REMARKS

ANNOTATED MARKED-UP DRAWING

FIG.2

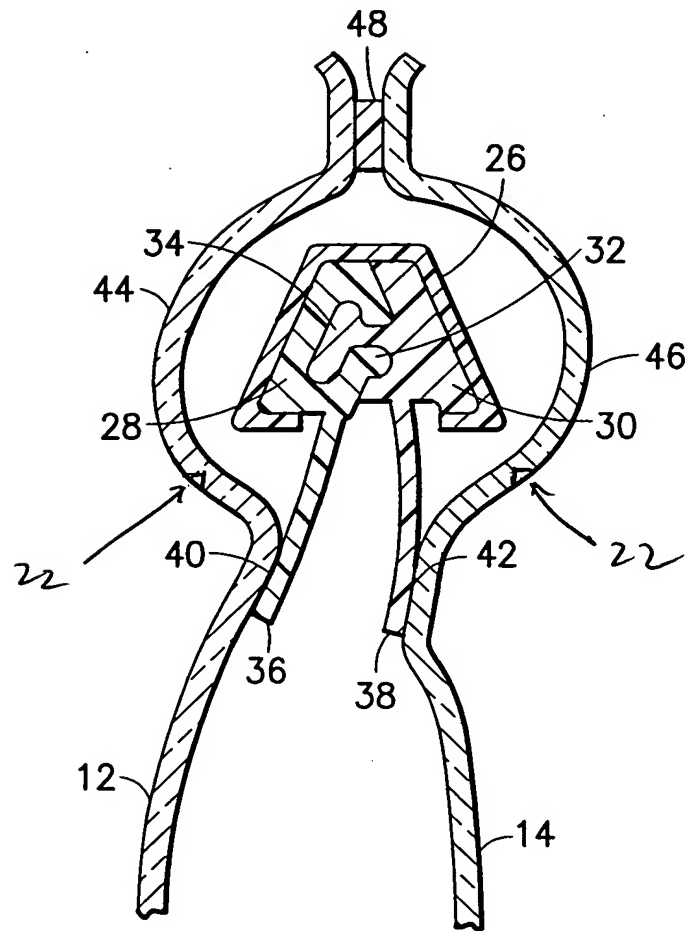
In ¶ 7 of the Office Action, the drawings were further objected to because Figure 2 fails to show the line of weakness 22. In response to this objection, the Applicants have proposed to amend Figure 2 to show the lines of weakness 22, thereby overcoming this objection as well.
